**DEFECT INFORMATION REPORT FOR DAIMLERCHRYSLER RECALL #C43**

Safety Recall #C43 - Instrument Cluster Capacitor  
STOP SALE ORDER

## **Safety Recall No. C43** **Instrument Cluster Capacitor**

Figure 8

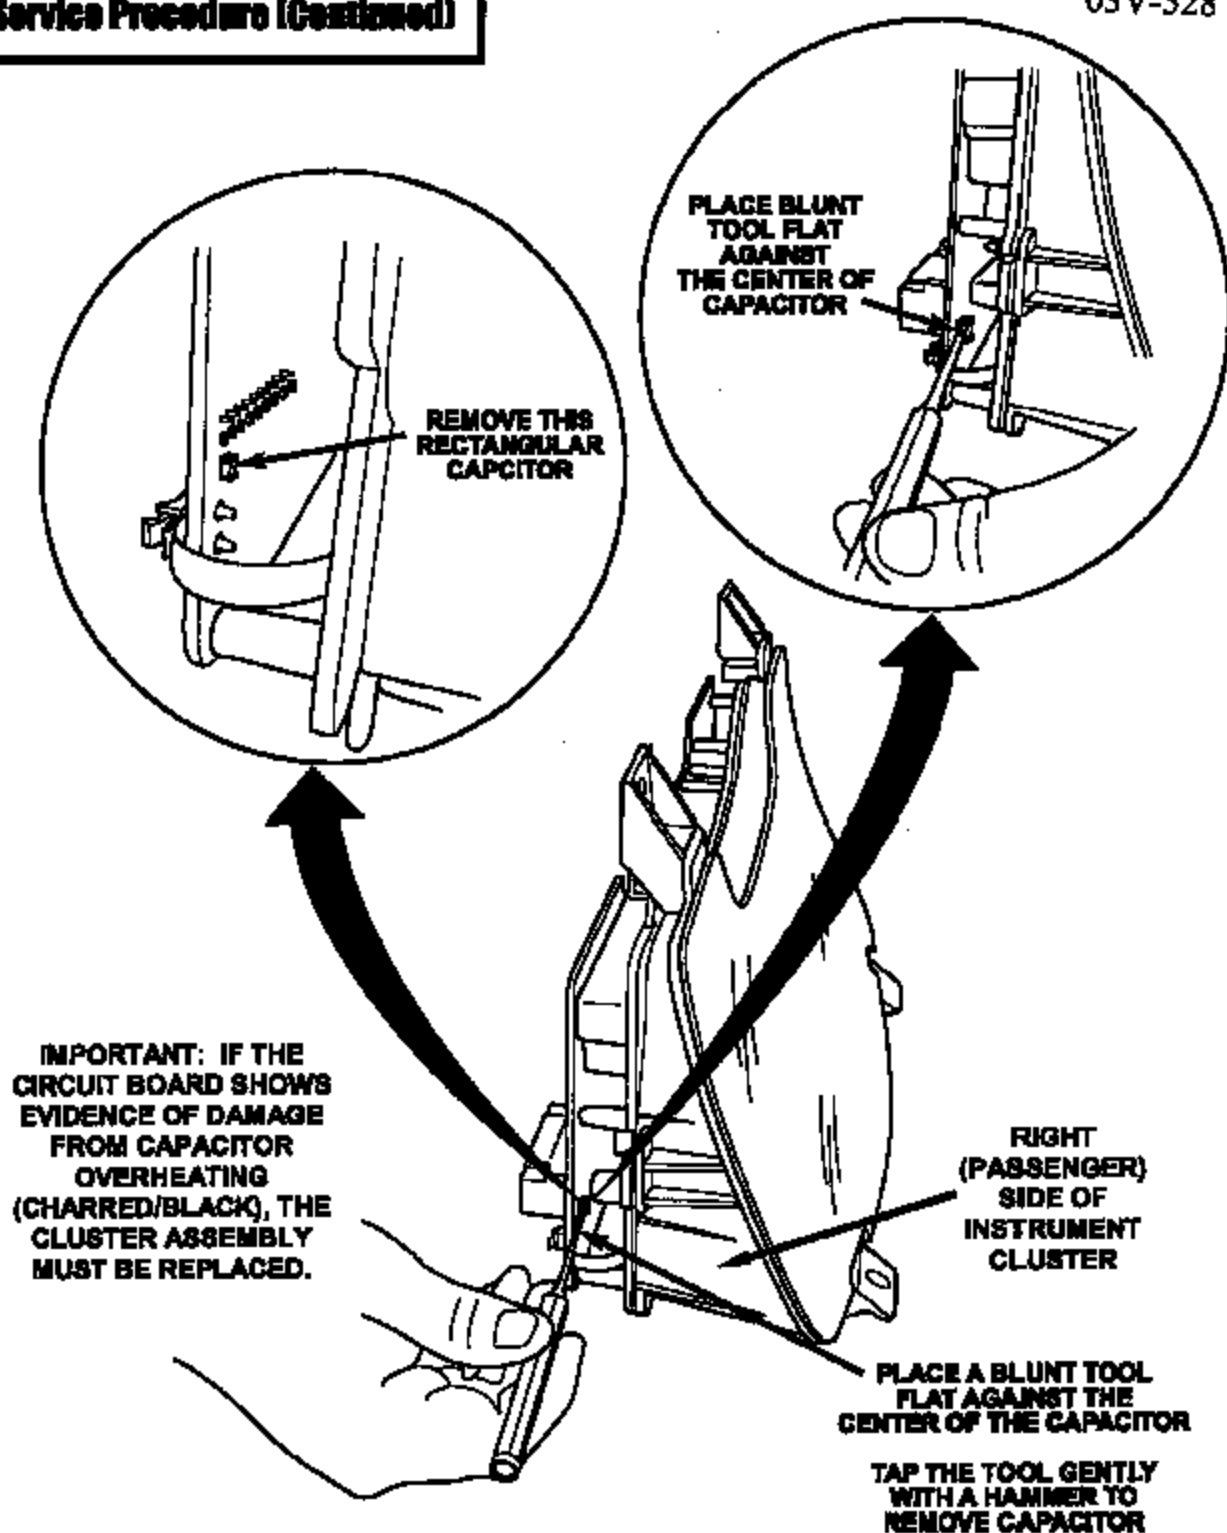
17. Place a **blunt tool** such as a 5/32" pin punch against the circuit board capacitor on the right (passenger) end of the circuit board (Figure 8). Do NOT use a tool that is wider than the overall width of the capacitor.

18. **Gently** tap the tool with a small hammer to separate and remove the capacitor from the circuit board. Keep the circuit board in the vertical position so that the removed capacitor falls away from the cluster assembly.

19. Inspect the capacitor location and ensure that all of the capacitor material has been removed from between the two terminals and make sure that the capacitor has fallen away and is not trapped within the circuit board assembly.

**IMPORTANT:** If the circuit board shows evidence of damage from capacitor overheating (charred/black), the cluster assembly must be replaced. Use normal service procedures to obtain a replacement cluster assembly.
